ADDENDUM NO. 2
TO
PLANS, SPECIFICATIONS
AND
CONTRACT DOCUMENTS
FOR

CITY OF MANTECA
WASTEWATER QUALITY CONTROL FACILITY

WQCF RECLAIMED WATER IMPROVEMENTS PROJECT

October 2016

DRAWING E10-3

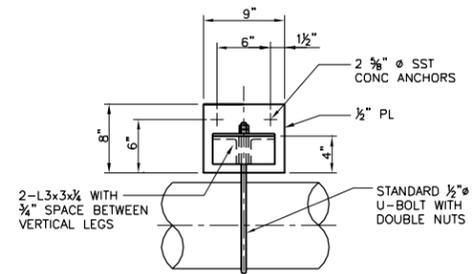
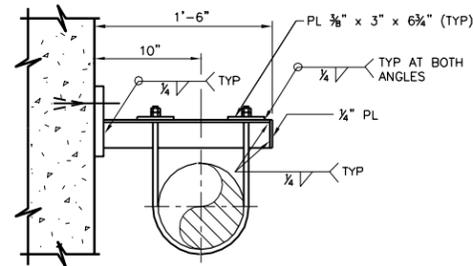
1. Modify the callout on the existing conduit north of the basin (running from the MCC to the wireway on the north wall) which currently reads "P0206, C0206, P0207, C0207, P0218, P0219" to read:

"P0206, C0206
P0207, C0207
P0208
P0218, P0219"

JOB NO.
2015-113 T01
DRAWING NO.
T-7-A2
SHEET NO.
8 OF 62

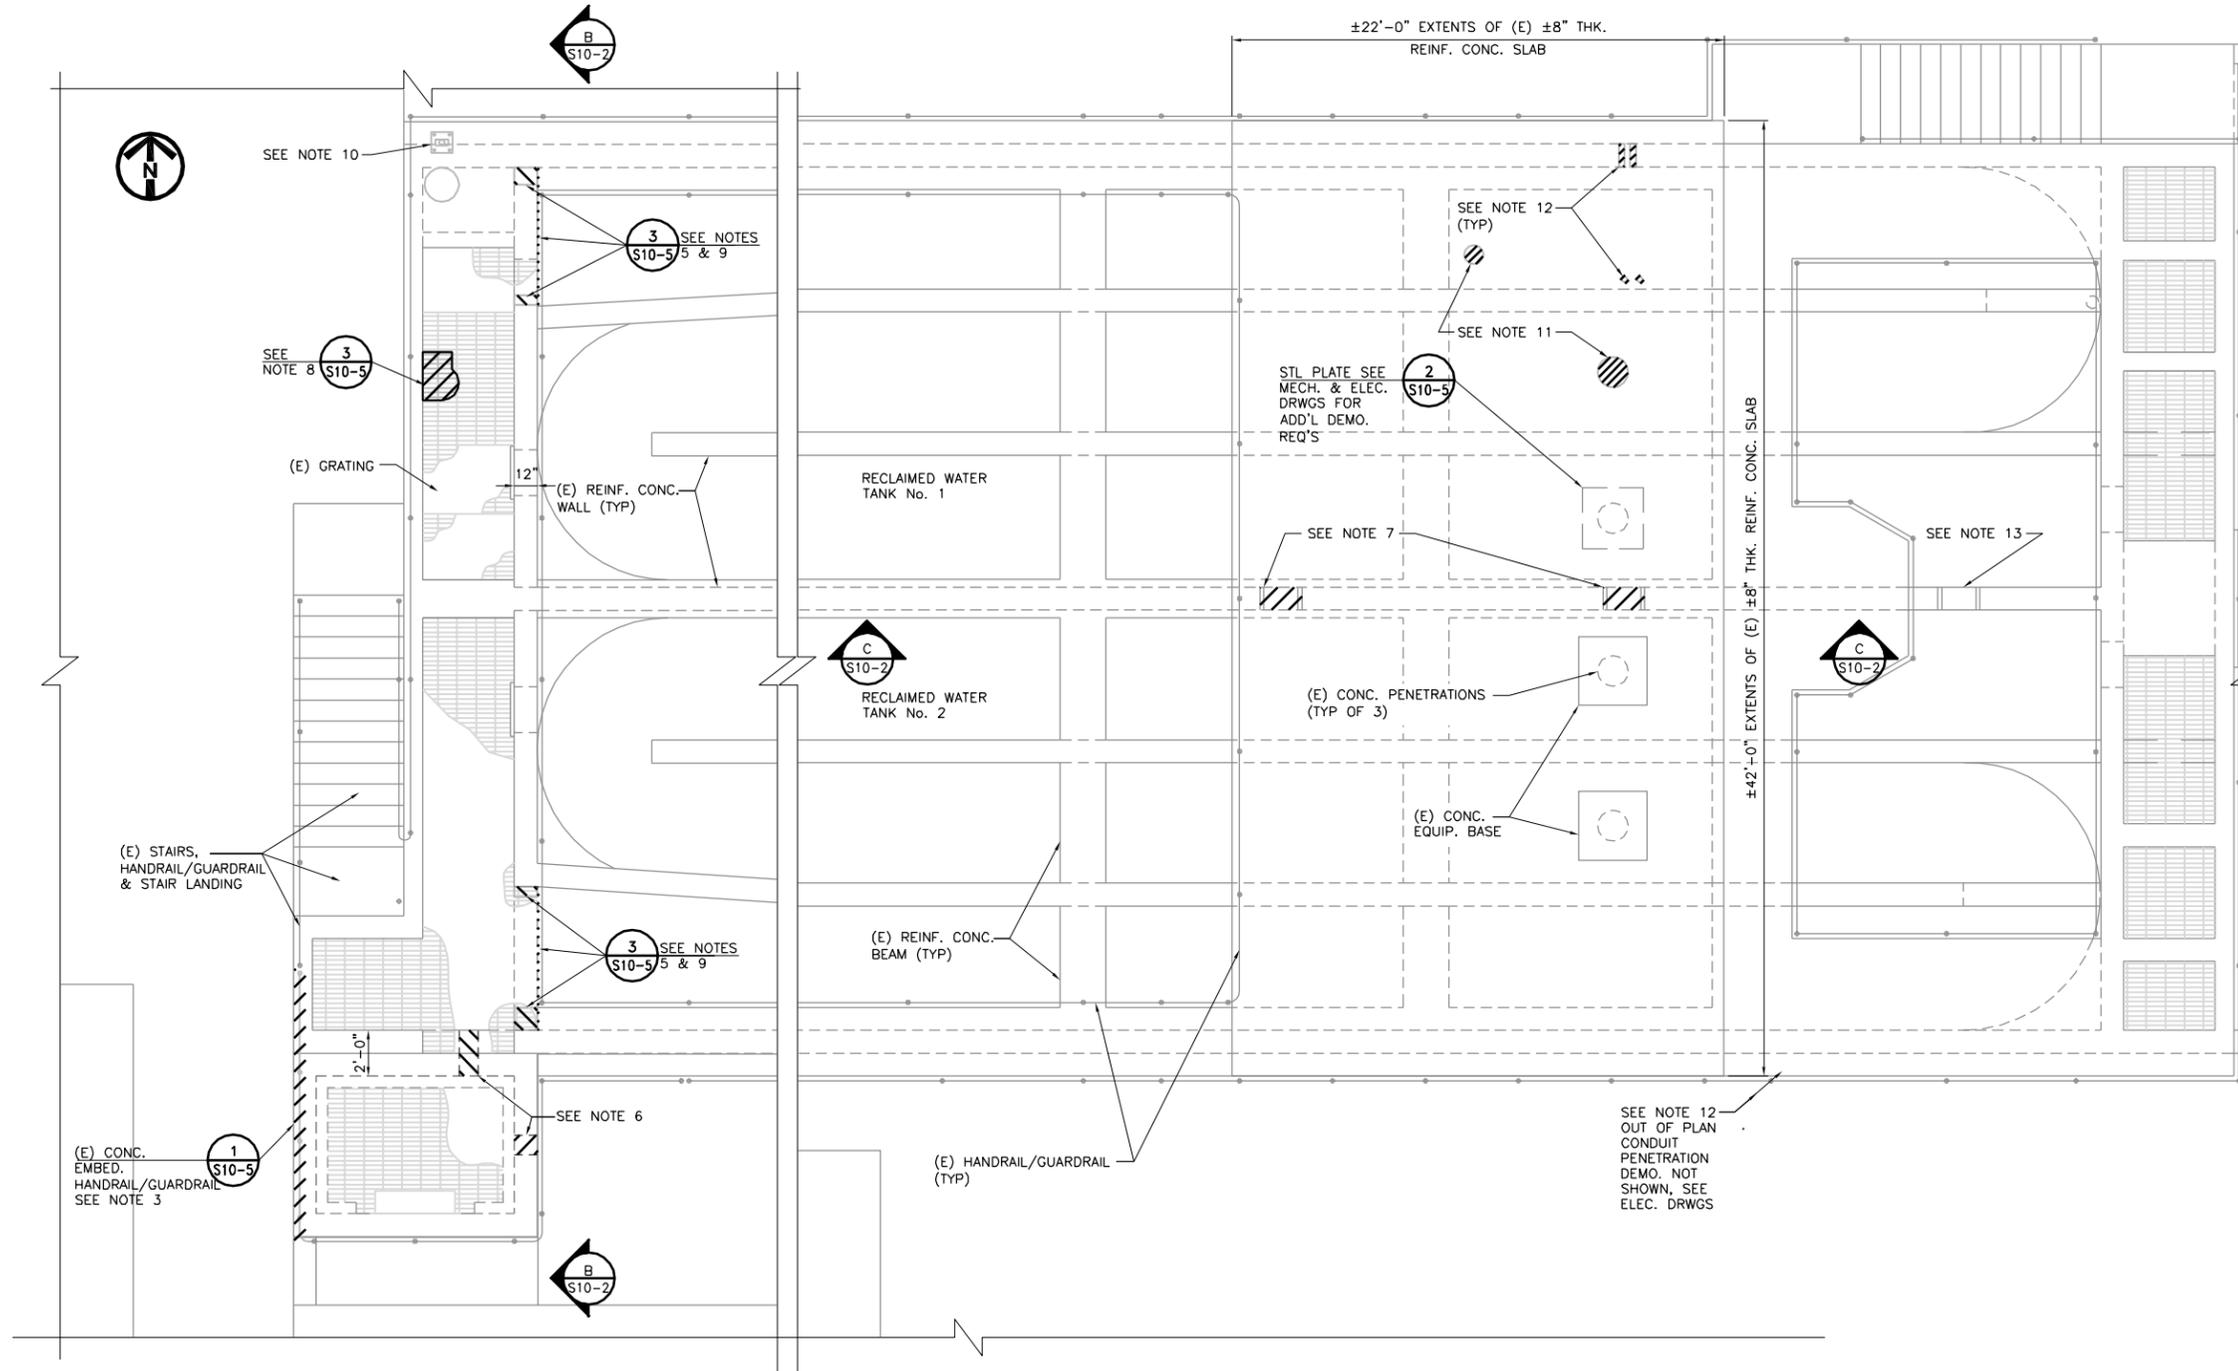
1. Replace Drawing T-7 with the attached Drawing T-7-A2.

JOB NO.
2015-113 T01
 DRAWING NO.
S10-1-A2
 SHEET NO.
18 OF 62

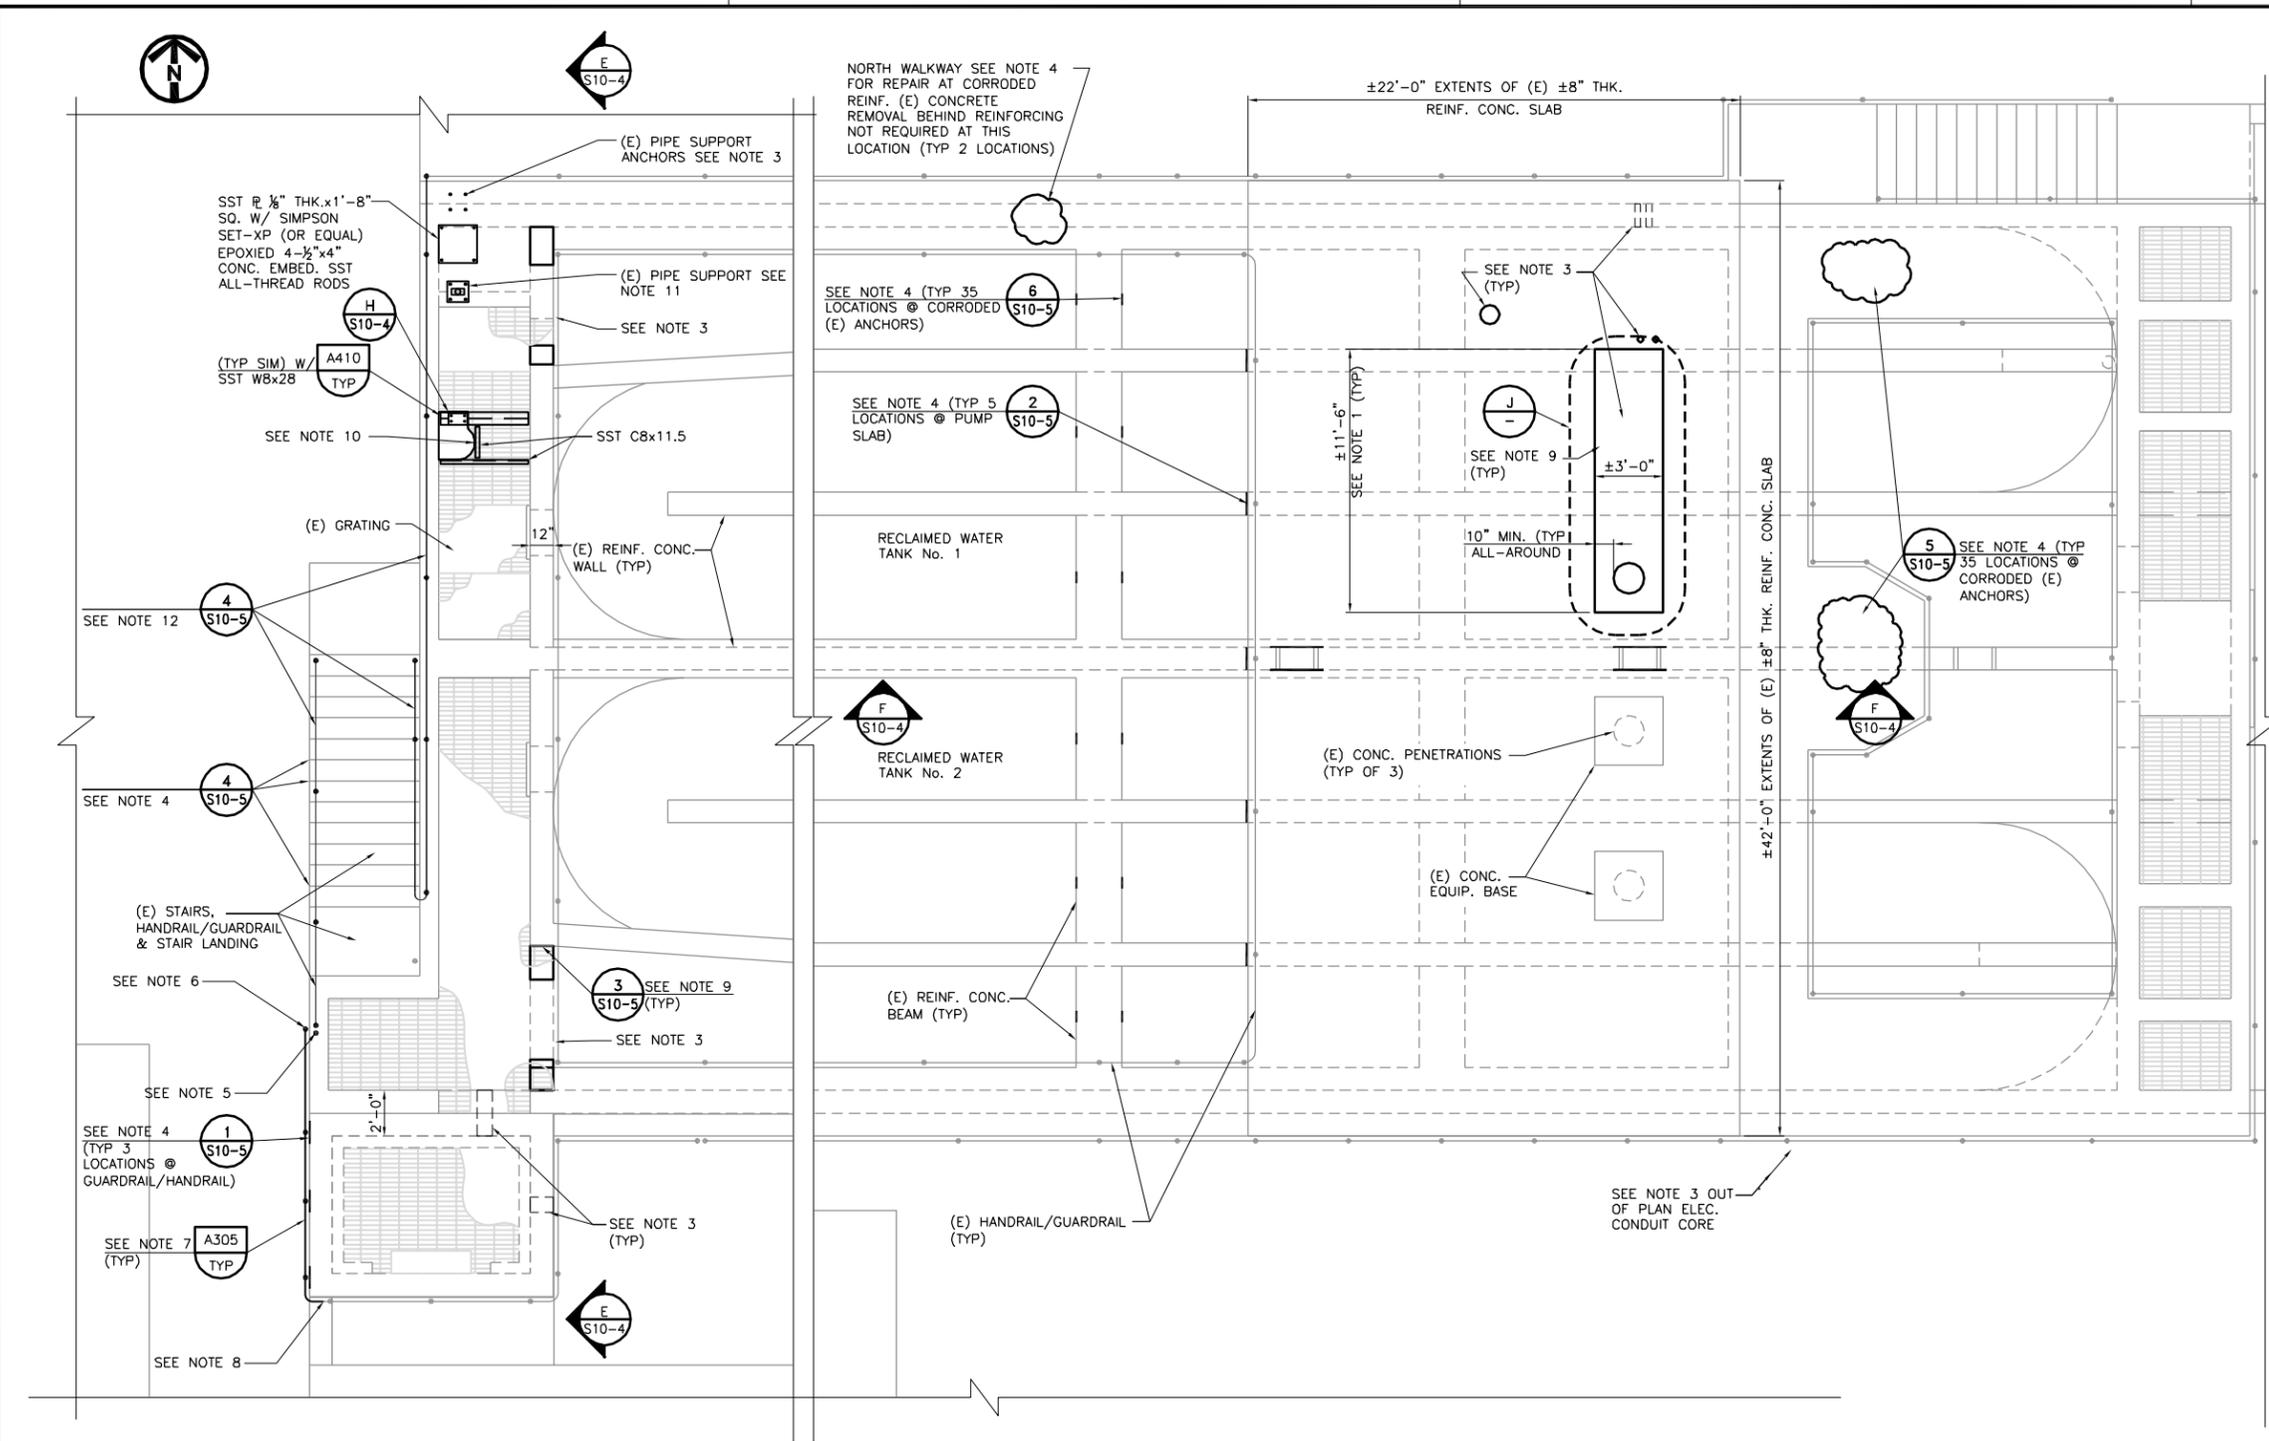
1. Replace Drawing S10-1 with the attached Drawing S10-1-A2".

JOB NO.
2015-113 T01
DRAWING NO.
S10-5-A2
SHEET NO.
22 OF 62

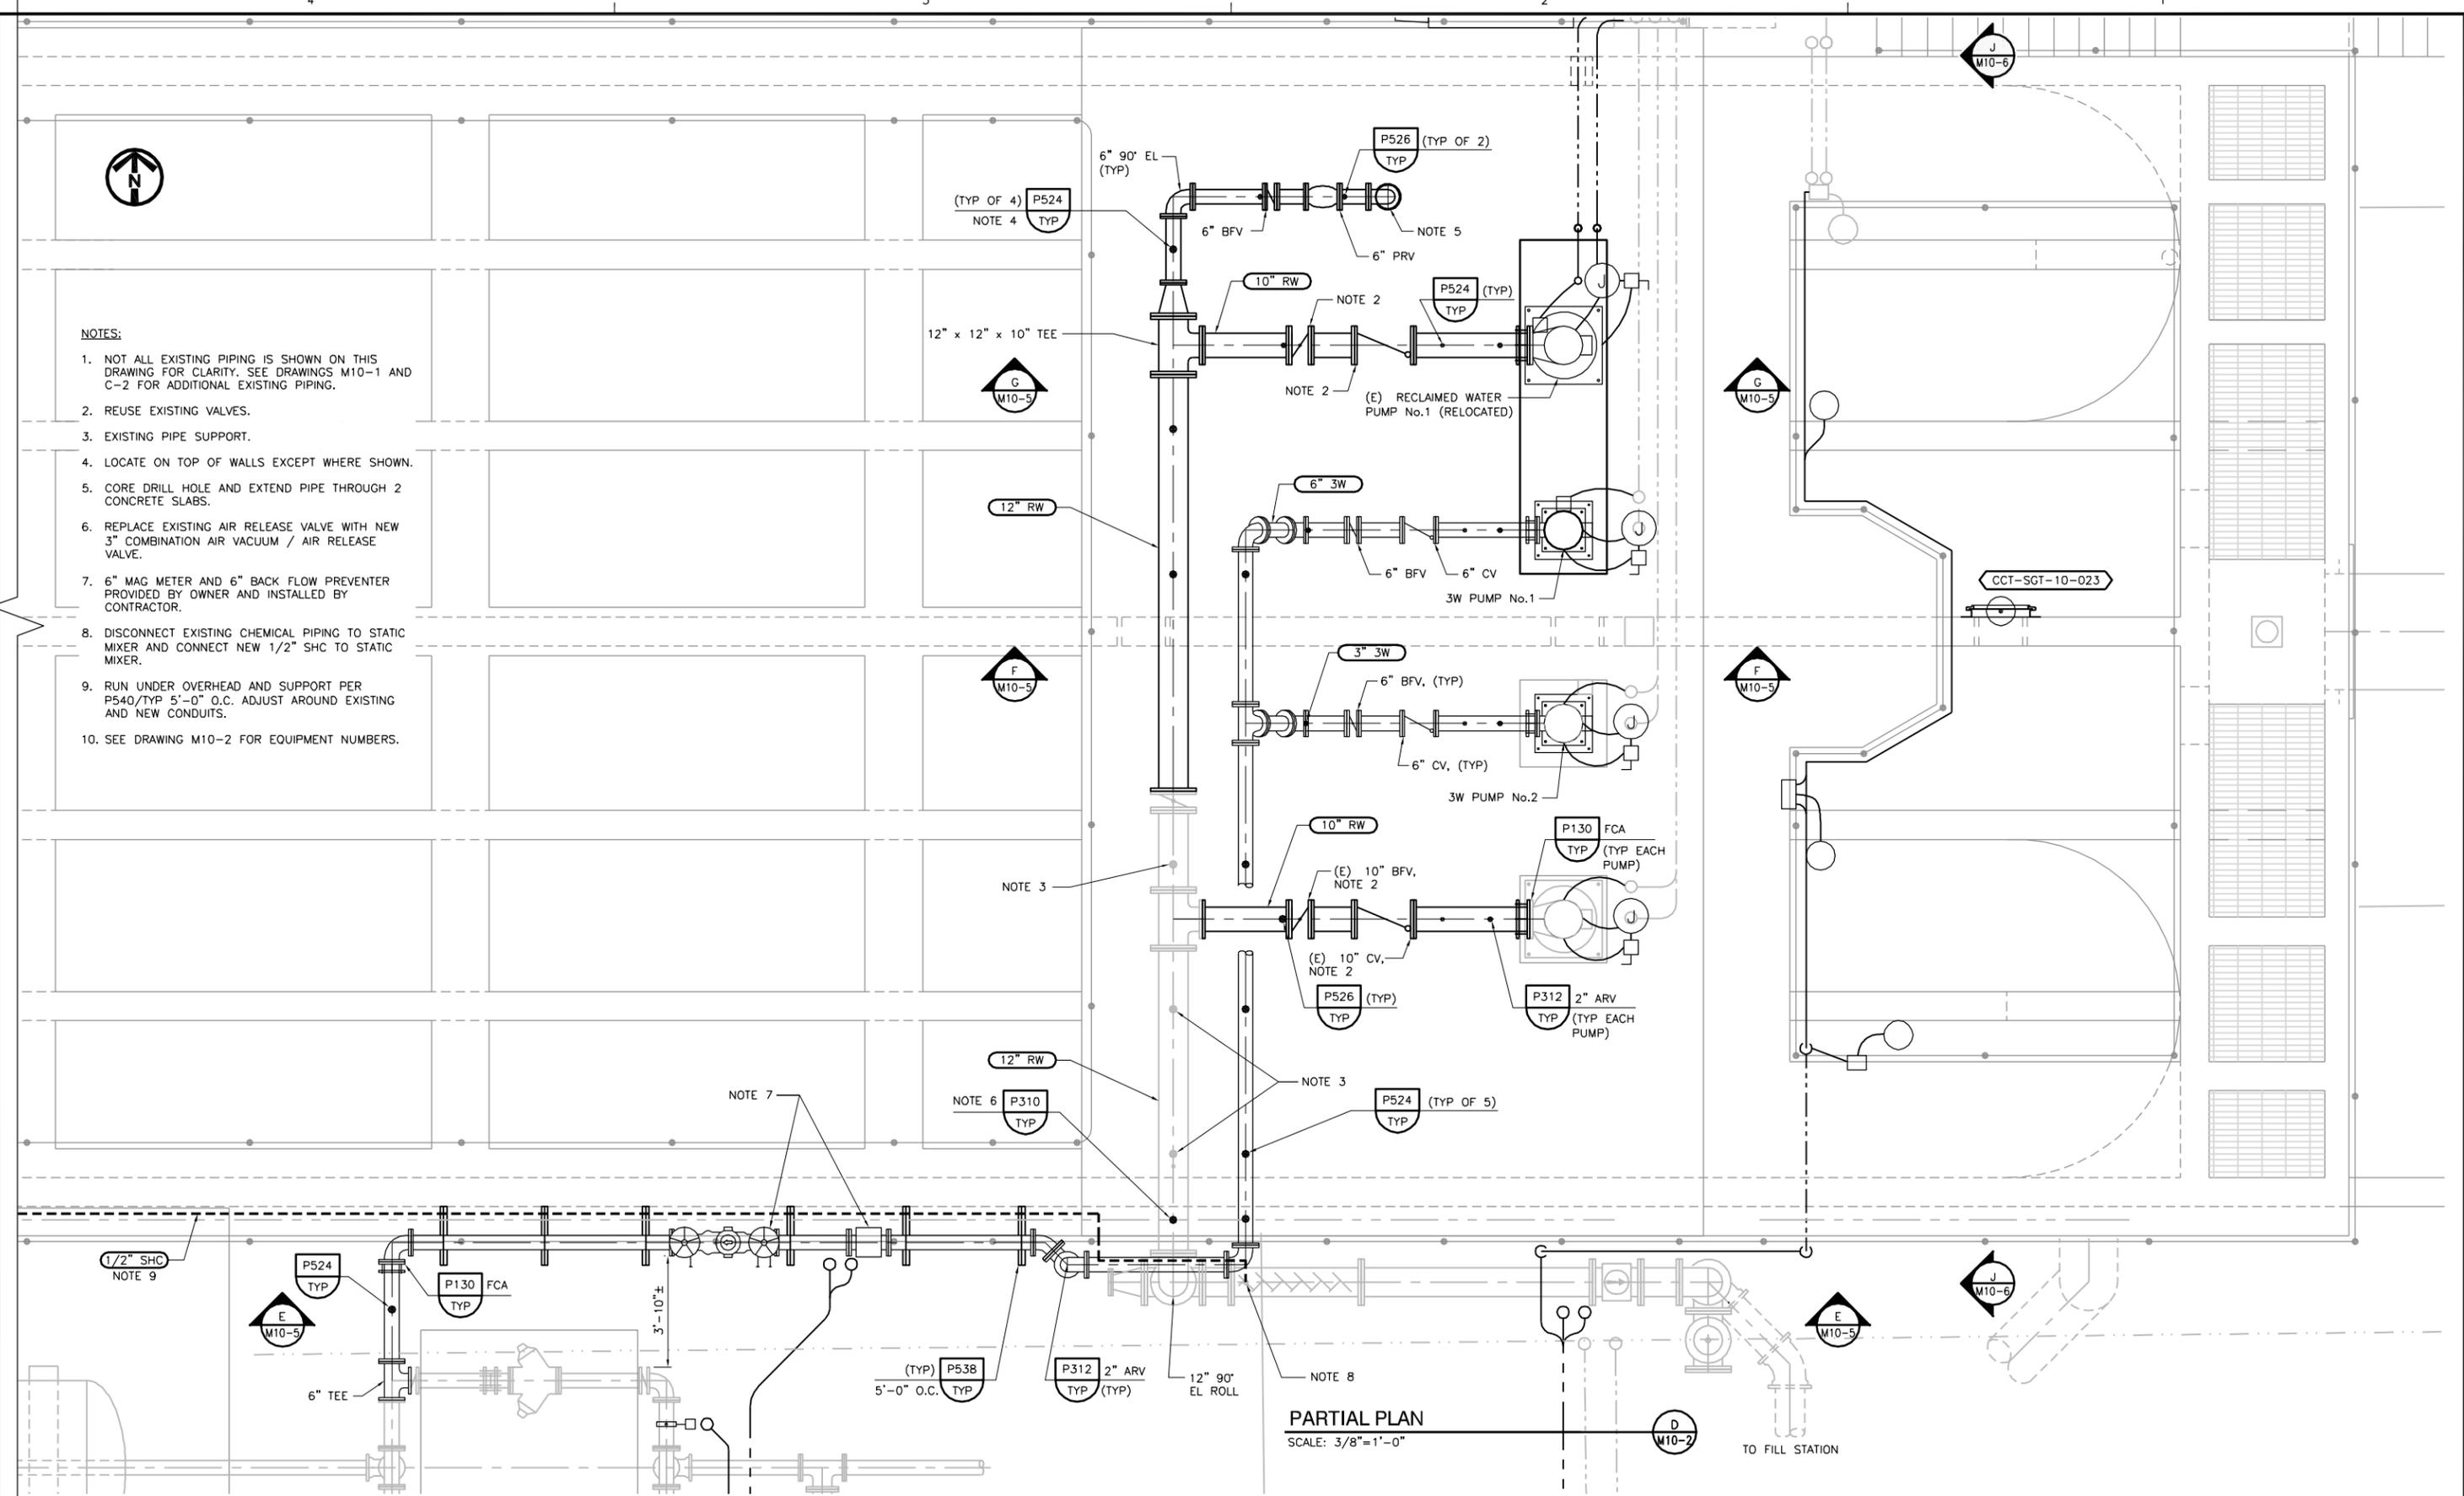
1. Replace Drawing S10-5 with the attached Drawing S10-5-A2.
